## Purpose and Use

This Addendum incorporates updated design hydrographs and supersedes analysis and conclusions as described herein.

Figure C.1. Revised 100-yr hydrograph (VCWPD 2008).

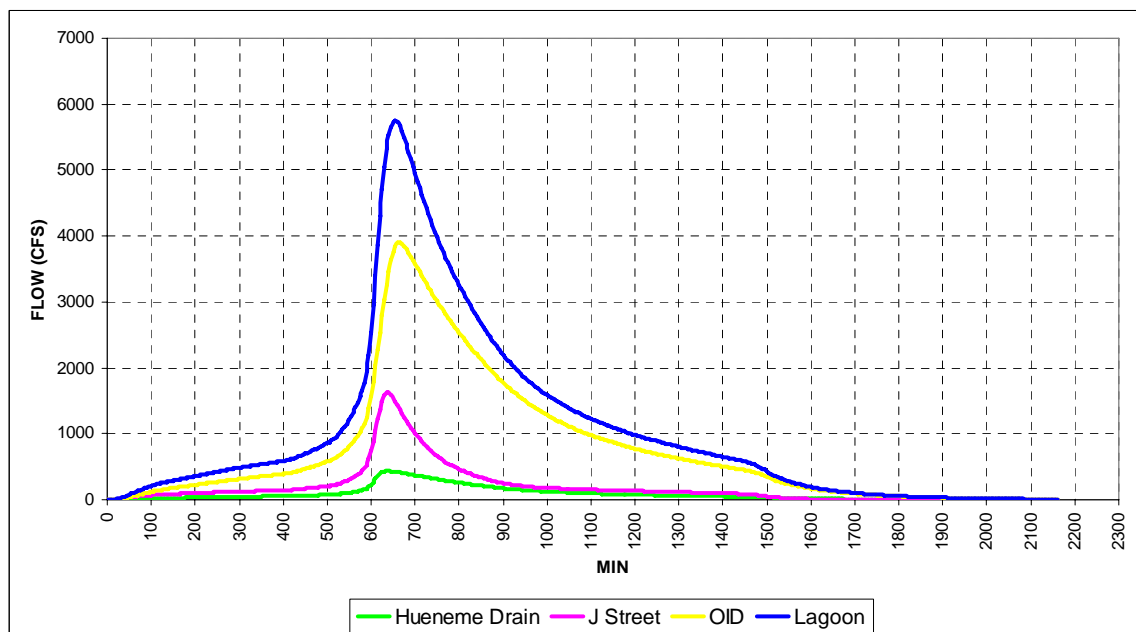
The revised hydrographs for the 100-yr event are shown in Figures C.1. Table C.1 compares peak flows for the original and revised hydrographs. Peak flows into the lagoon for the revised hydrograph are about 500 cfs higher than in the original analysis. In the revised analysis, flows are much higher within J Street, slightly higher within Hueneme Drain, and slightly lower within the OID.
